Work Order ID 96874

Item Name: Crosstube Mid Fwd, Blue

DART AEROSPACE LTD HAWKESBURY, ONTARIO, CANADA	
DRAWING NO. D206-667-147	REV. A SHEET 1 OF 4
TITLE CROSSTUBE ASS'Y (206L MID FWD)	SCALE NTS

DRAWING NO. D206-667-147	TITLE CROSSTUBE ASS'Y (206L MID FWD)	REV. A	DART AEROSPACE LTD ENGINEERING ORDER		D.E.O. NO. D206-667-147-A-1	SHEET NO. SHEET 1 OF 1	SCALE NTS
DRAWN 97	CHECKED ASS	MFG. APPR. [Signature]	APPROVED [Signature]		DE APPR. [Signature]		
DATE 11.07.15	DATE 11.07.20	DATE 11.07.21	DATE 11/07/21		DATE 11.07.21

DETAIL P
BONDING STRAP INSTALLATION 2 PL

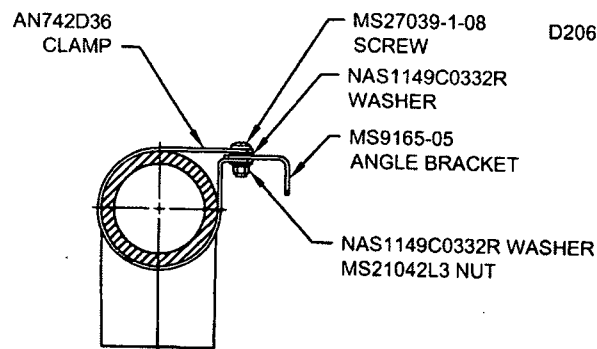
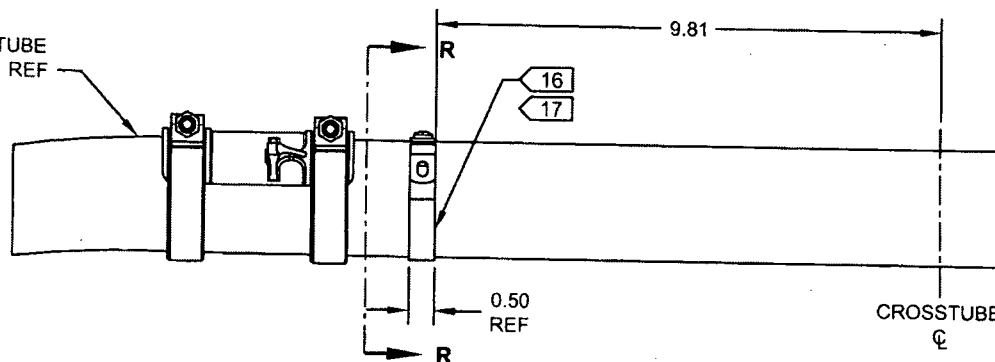
ADD ELECTRICAL GROUNDING STRAP

- 16) MASK AREA UNDER CLAMP PRIOR TO PAINTING
- 17) SEAL EDGES WHERE AN742D36 CLAMP MEETS WITH THE CROSSTUBE USING SIKAFLEX-241/-291 OR MIL-S-8802 CLASS B2 OR PROSEAL 890 SEALANT
- 18) PERFORM RESISTANCE CHECK TO ENSURE MAX RESISTANCE IS 10 MILLIOHMS
